HALCYON LAKE ESTATES

PROJECT INFO
HALCYON LAKE ESTATES
A PORTION OF THE SW 1/4 OF SECTION 21, T.6N R.2W SALT LAKE BASE & MERIDIAN WEBER COUNTY, UTAH

PRELIMINARY PLAT

SHEET NAME
PP-01
SHEET 1 OF 2

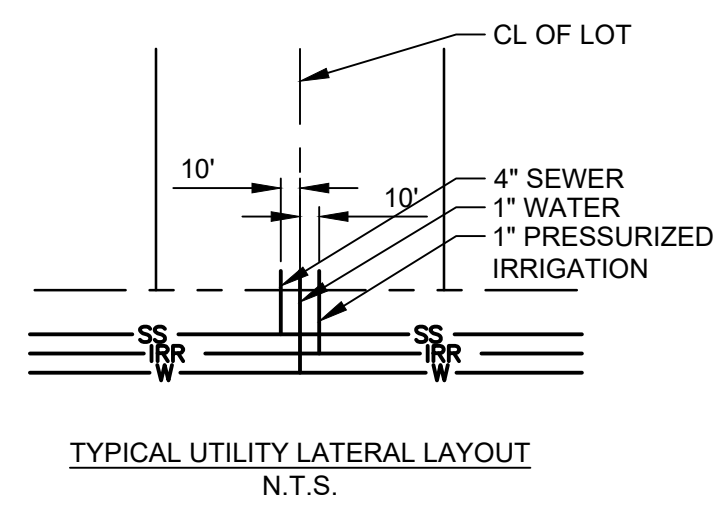
Please provide a table on the subdivision plat showing the area and width of each lot within the overall subdivision boundary, the average area and width of all lots within the overall subdivision boundary, and the average area and width of all lots within each zone in the subdivision. LUC 106-2-4(b)(5)e

Please include a subtitle on the plat that reads "A Lot-Averaged Subdivision" LUC LUC 106-2-4(b)(5)f

A note shall be placed on the final subdivision plat that reads "for each zone in this subdivision, the average area and average width of lots within the zone equal or exceed the minimum area and minimum width allowed in the zone. An amendment to any part of this subdivision shall comply with Section 106-2-4(b) of the Weber County Code." 106-2-4(b)(5)g

What is left of this remainder parcel?
When a division of property leaves a remaining area of 5.00 acres or greater, the remaining parcel boundary and area, using record or measured information will be shown, on the subdivision plat with the note: "Remaining Agricultural Parcel, Not Approved For Development." The remaining parcel boundary need not be labeled with bearings or distances nor is a description of the remainder parcel required. Remaining parcels are not part of the subdivision. LUC 106-1-8(c)(3)

What can be done to make more road connectivity to these adjacent properties?
Here is what the subdivision ordinance requires for connectivity.
LUC106-2-1(a)
The arrangement of streets in new subdivisions shall make provision for the continuation of the existing streets in adjoining areas (or their proper protection where adjoining land is not subdivided) insofar as such may be deemed necessary by the planning commission for public requirements. The street arrangement must be such as to cause no unnecessary hardship to owners of adjoining property when they plat their own land and seek to provide for convenient access to it.

Provide a stub through this open space to provide connectivity.

Is this owned by the developer? Please identify what this is or what the plan for this is.

This cul-de-sac will need to be a continuation of a road. See below:
Minor terminal streets (cul-de-sacs) proposed in the subdivision of flat land where topography presents no barriers to development, shall have a maximum length of 650 feet to the beginning of the turnaround and may serve a maximum of 14 lots. Minor terminal streets (cul-de-sacs) proposed in the subdivision of foothill or mountainous lands where topography dictates or limits the options in road design to a considerable extent, the planning commission will establish a maximum length based upon each individual situation. As a guide for design, a maximum length of 2,000 feet to the beginning of the turnaround is established. Each cul-de-sac shall be terminated by a turnaround of not less than 100 feet diameter in subdivisions below elevation 4,900 feet and of not less than 110 feet diameter in subdivisions above elevation 4,900 feet. If surface water drainage is into the turnaround, due to the grade of the street, if necessary, catchbasins and drainage easements shall be provided. LUC 106-2-2(d)

The streets in this subdivision must be public. See below:
Streets in year round subdivisions shall be dedicated to the county as public streets except that private streets improved to county public street standards may be permitted in planned residential unit developments or condominiums. Mountain land subdivisions in high mountain areas of the county for seasonal recreation and summer homes shall have private streets built to county private street standards for such subdivisions except that the county may require public dedication for major or loop road access purposes. 106-2-2(a)
